CONNECTICUT YANKEE

SAFETY RELATED PIPING

SEISMIC QUALIFICATION PROGRAM

REVISION 2

FIGURE 1

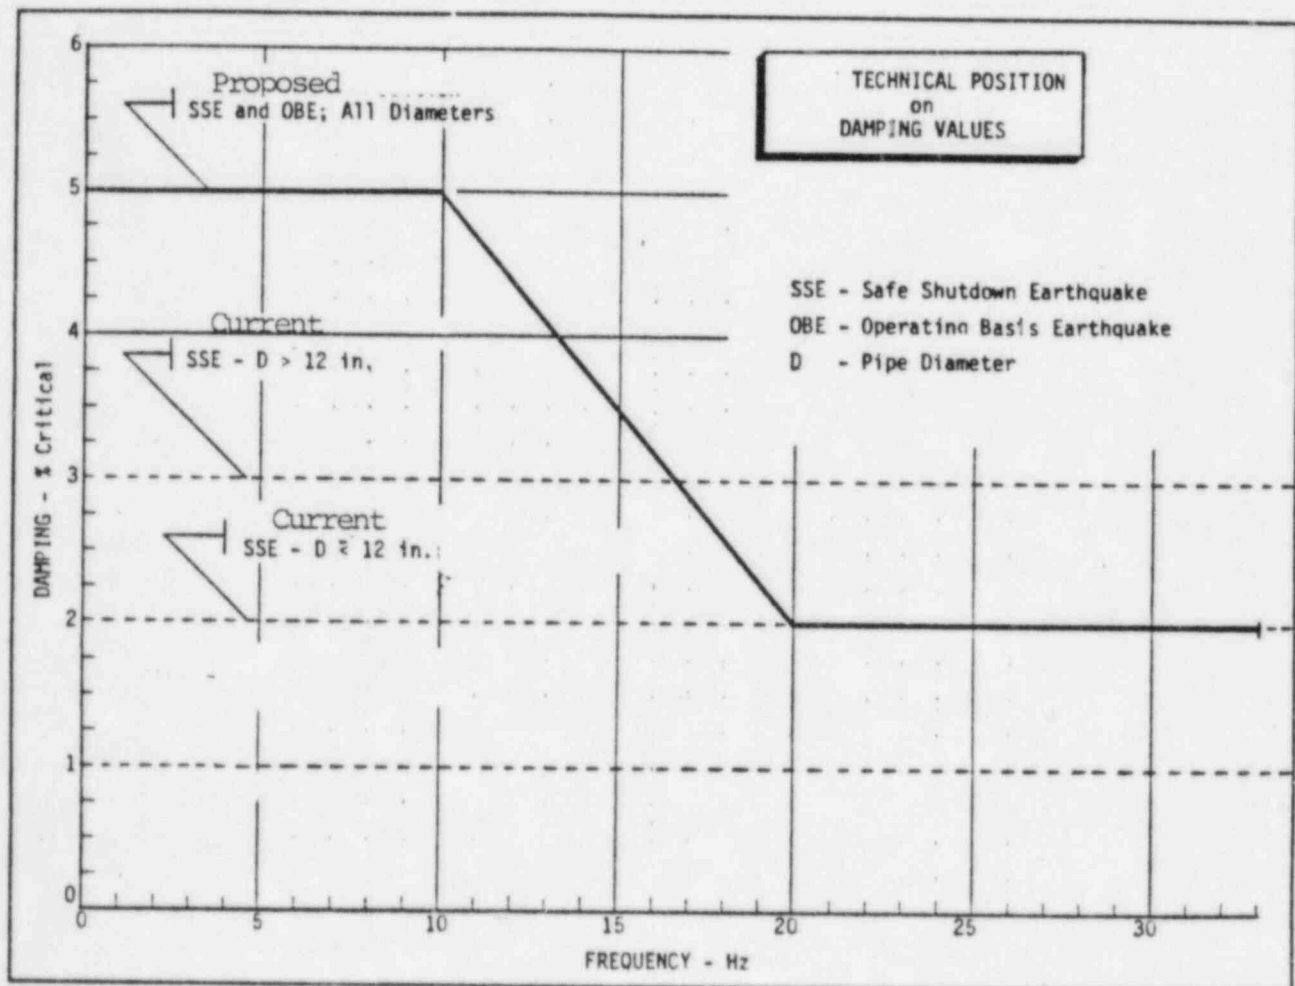
Analysis will be performed assuming that the seismic event is initiated with the plant at normal full power condition. The SSE damping values used^(E) are 3% for nominal pipe diameter greater than 12" and 2% for nominal pipe diameter equal to or less than 12" except that increased damping values may be applied on an as-needed basis in accordance with ASME Code N-411^(G) (Figure - 1).

Page added by Revision 3
